Technical Note TN-853 TMAA02-01 Rugged Microphone Rework Instructions

31 March 2004

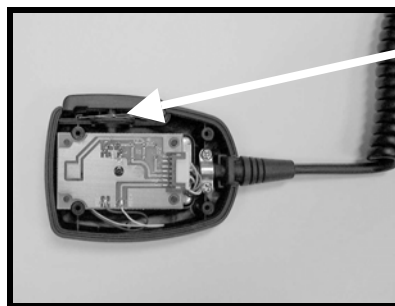
The microphones were tested and the fault traced to a shortening of the PTT lever boss length of 0.5mm by the supplier.

The shortened length of this boss manifested as two problems:

- The point of microswitch transmit activation was much greater than the required 50% of travel.
- It required users to apply more than the expected pressure to keep the microswitch keyed.

- Source replacement PTT levers from TEL. The IPN is **311-01055-00**.
- Remove the four screws from the rear housing and remove the existing PTT lever from the front housing
- Replace the PTT lever, ensuring the rubber seal/plunger (as arrowed below) is correctly seated in the front housing guide before replacing the rear housing. This is important as it will affect the IP54 rating.

The correct PTT lever will be identifiable at any time by the letter 'B' marked inside the PTT lever.
